**NOTICE OF MEETING
LANDMARK COMMISSION
OF THE CITY OF GALVESTON
MONDAY, MARCH 16, 2026 - 4:00 PM
CITY COUNCIL CHAMBERS, 2ND FLOOR OF CITY HALL
823 ROSENBERG, GALVESTON, TEXAS
REGULAR MEETING**

26LC-003

STAFF REPORT

1815 Broadway / Avenue J

Request for approval:

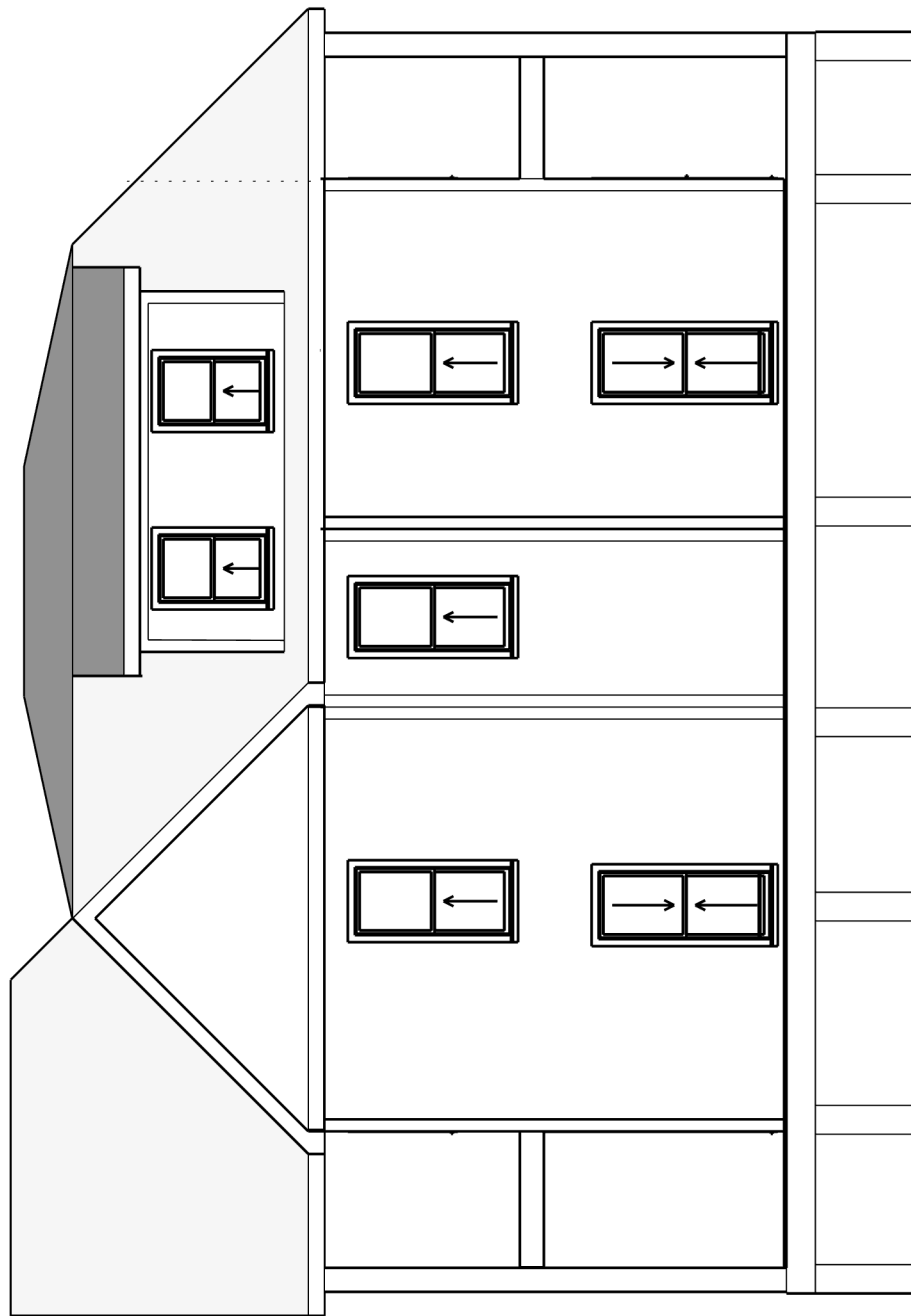
Restore the Original Front Façade

These modifications are in Location A: Primary Façade in which preservation and repair of features in place is the priority. The Design Standards state that adding architectural details not common to a particular architectural style, without evidence of such, is

inappropriate. However, the applicant has provided a narrative that suggests the historically extant house at 1717 Postoffice / Avenue E may be a suitable “pattern house” for restoration of the subject property. The *Galveston Architecture Guidebook* By Ellen Beasley and Stephen Fox, (page 114), notes the house at 1815 Broadway is a simplified version of the Elise Michael house at 1717 Postoffice, but there is no detail provided about how simplified it was. And, no historic photographs are known to exist of either property before the 1960s. Note that the front façade of 1815 Broadway shares the same overall massing, fenestration, and some decorative elements with 1717 Postoffice, such as the ornate handrails, three-bay porch, and decorative front gable treatments. A HABS photo from the 1960s indicates that if 1815 Broadway was similar to 1717 Postoffice its historic façade was lost long ago (see applicant’s narrative). Staff recommends approval of the request to restore the façade to a presumed historic appearance alike to 1717 Postoffice using compatible materials (wood).

Front Door Replacement

The applicant proposes to replace the existing front door with an exact reproduction. The existing doors appears to be narrow double doors with arched lights common to houses of the same general style and period as the subject house and pattern house. Because rebuilding and retaining historic front doors is preferable to replacement, staff recommends rebuilding/restoring over replacement (note the applicant provided no evidence that the existing front door cannot be repaired and restored).

1. The exterior modifications shall conform to the design, materials and placement presented in Exhibit A of the staff report, with the following modifications:
 - a) Restoration of the front façade shall conform to the design, style, and historic materials (wood) of the pattern house at 1717 Postoffice;
 - b) Any historic windows removed shall be retained on-site or made available to a third party for reuse;
 - c) The siding on the proposed dormer shall be wood or smooth cement fiber board; and
 - d) The existing front door shall be repaired and restored if possible. If not possible, the applicant shall provide drawings of the proposed replacement and photos of the existing door for Historic Preservation Officer review;

Photo of Stair Rail at “Sister House” and drawing of proposed Stair Rail at 1815 Broadway

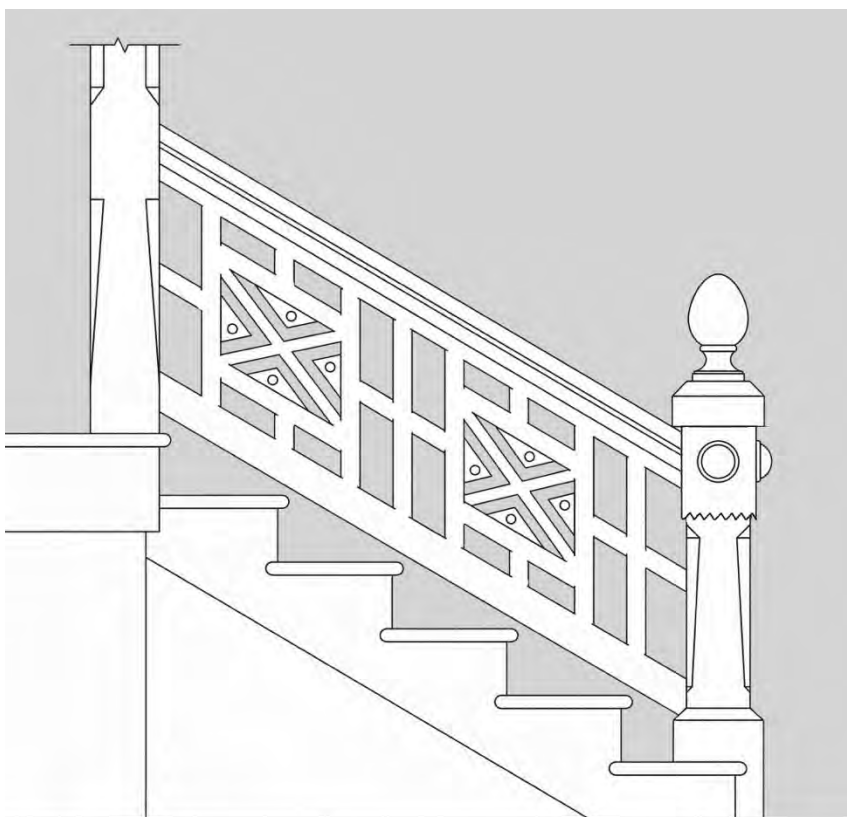
Note pine cone newel cap, bossing on apron and sawtooth pattern at bottom of apron.
